REQUEST FOR PROPOSAL

Project Title: Cooley Laboratory Renovation
Location: Montana State University

PPA No.: 10-0023
RFP No.: 27
Date: 01/13/12

RFP for the Addition of Video Monitors -Wall assembly at Piping

Reference Drawings: A1.8 A1.6-A1.4+A1.2-A1.0

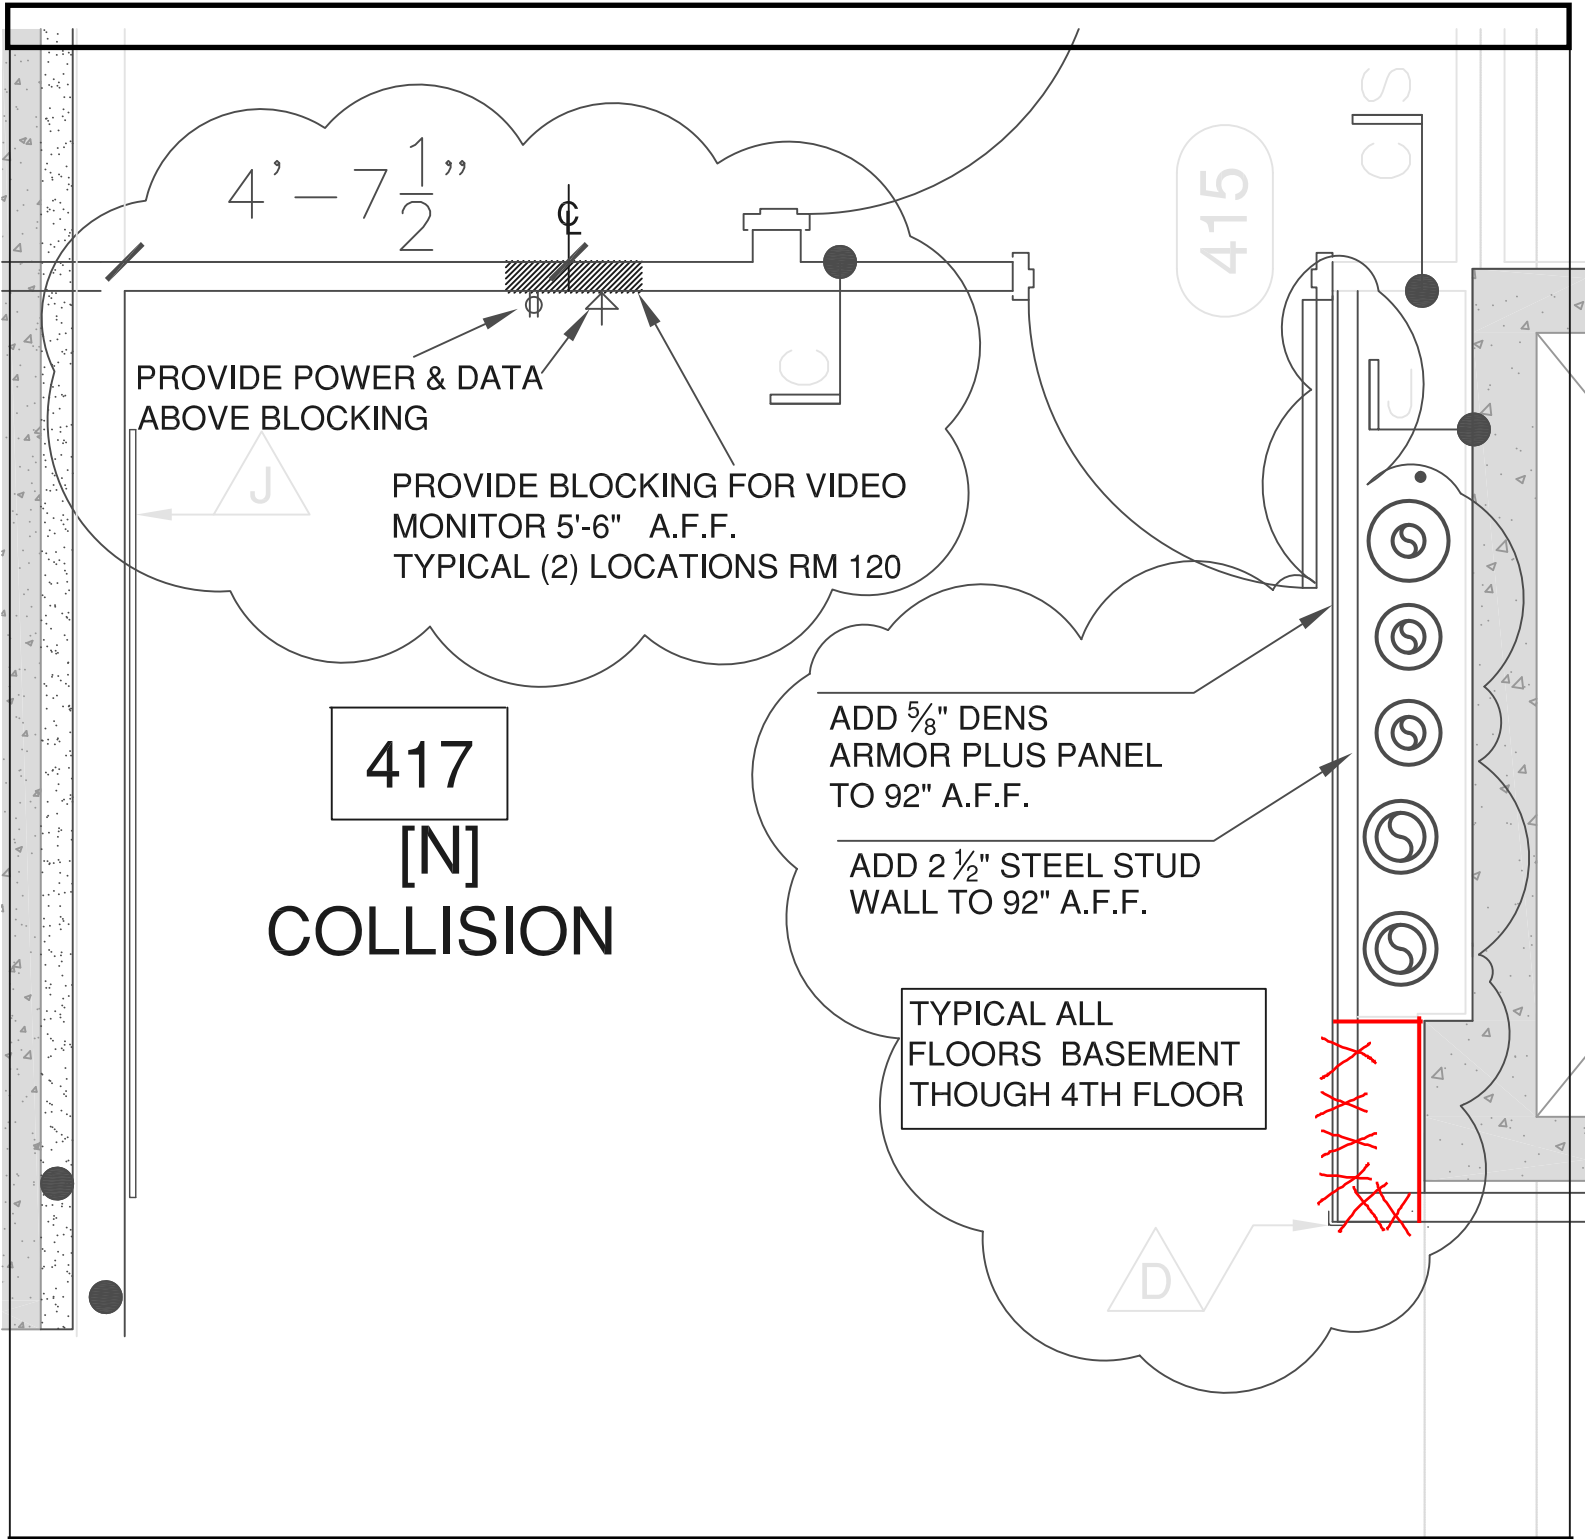
- **PROVIDE** Backing for New Video Monitor @ Collision Areas 4th and 1st Floors as shown on RFP 27-1 Provide new electrical and data outlet as shown. Electrical Power from panel L4A and L1B.
- **Provide** New 2 1/2" wall assembly @ pipe chases as shown.

RFP 27-1
VIDEO MONITORS @ COLLISION AREAS
NEW 2 1/2" WALL AT PIPE CHASE

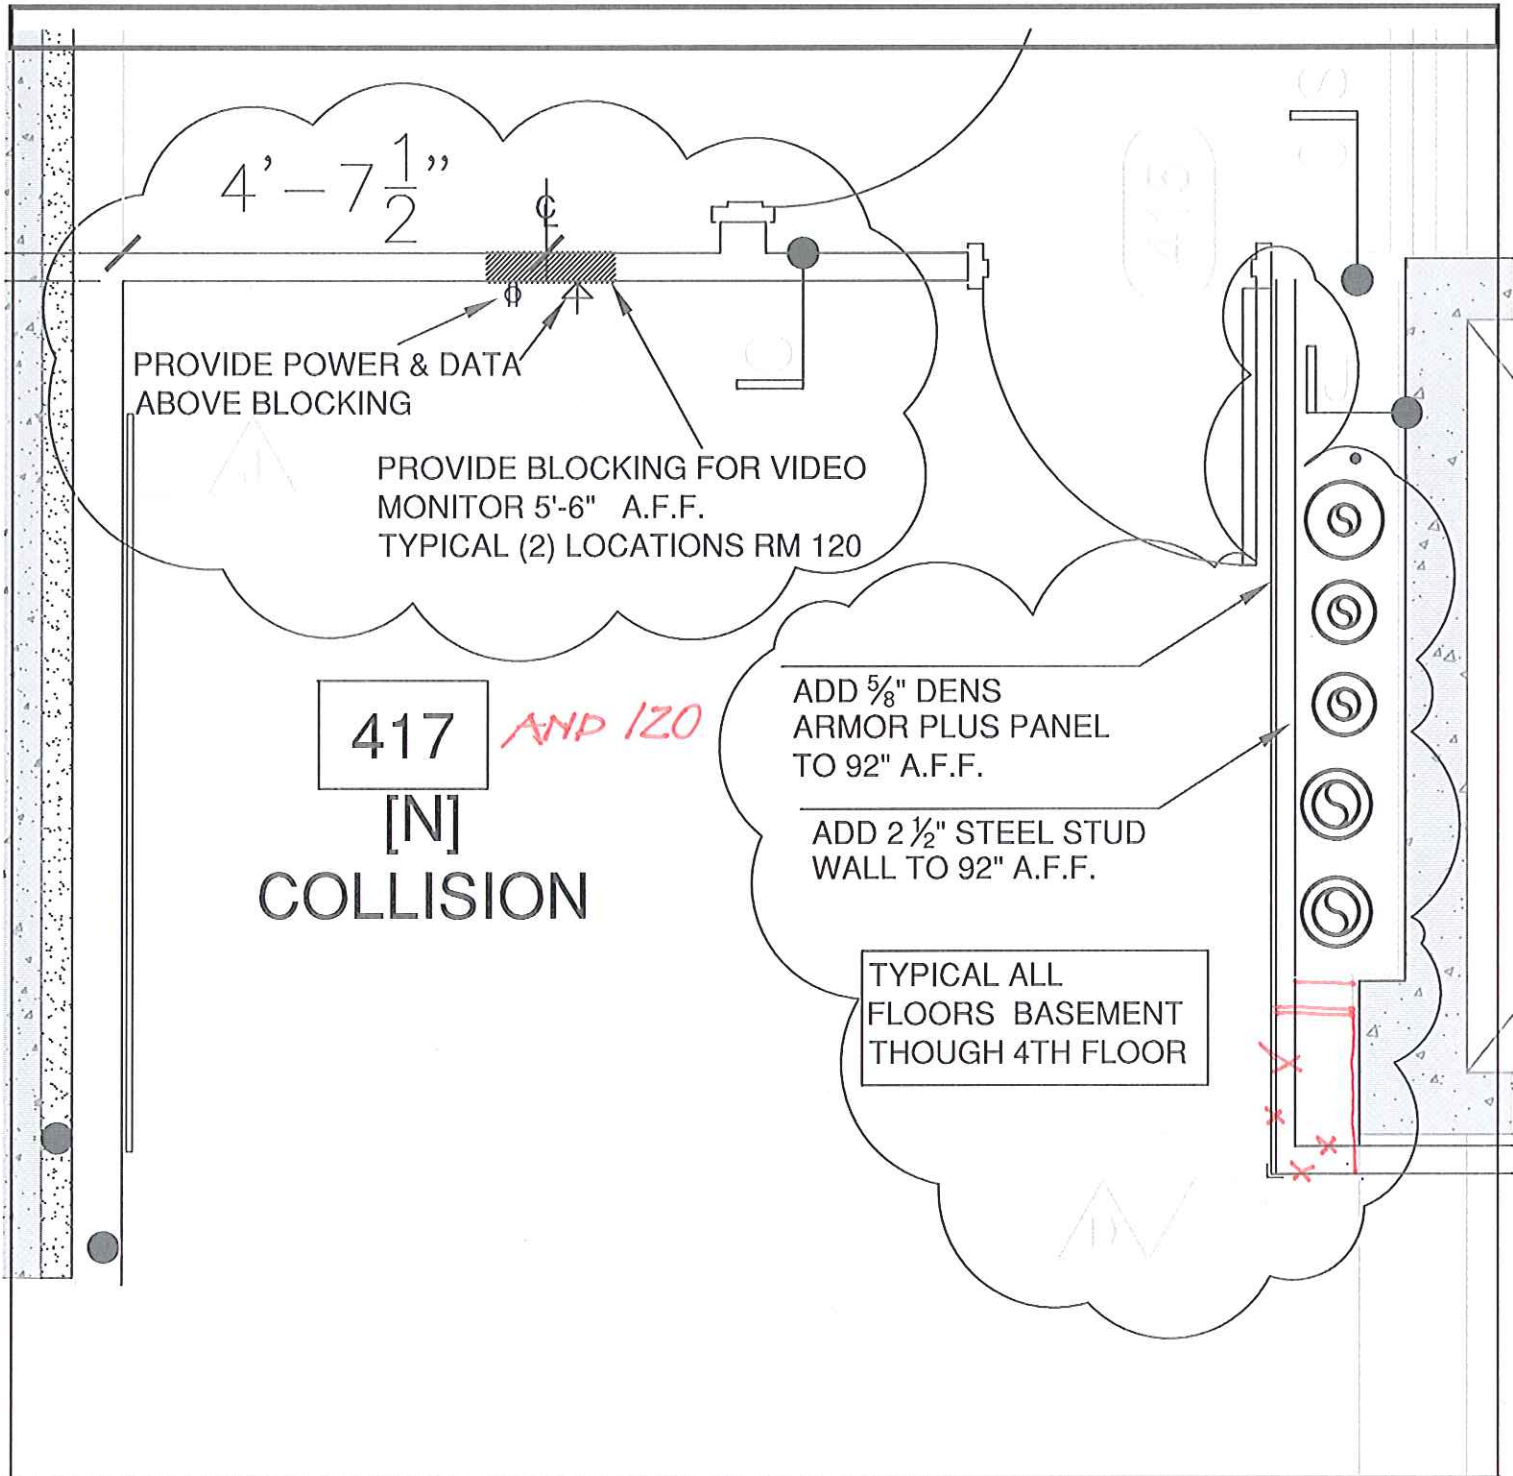
PROVIDE POWER & DATA ABOVE BLOCKING

PROVIDE BLOCKING FOR VIDEO MONITOR 5'-6" A.F.F. TYPICAL (2) LOCATIONS RM 120

ADD 5/8" DENS ARMOR PLUS PANEL TO 92" A.F.F.

ADD 2 1/2" STEEL STUD WALL TO 92" A.F.F.

TYPICAL ALL FLOORS BASEMENT THOUGH 4TH FLOOR
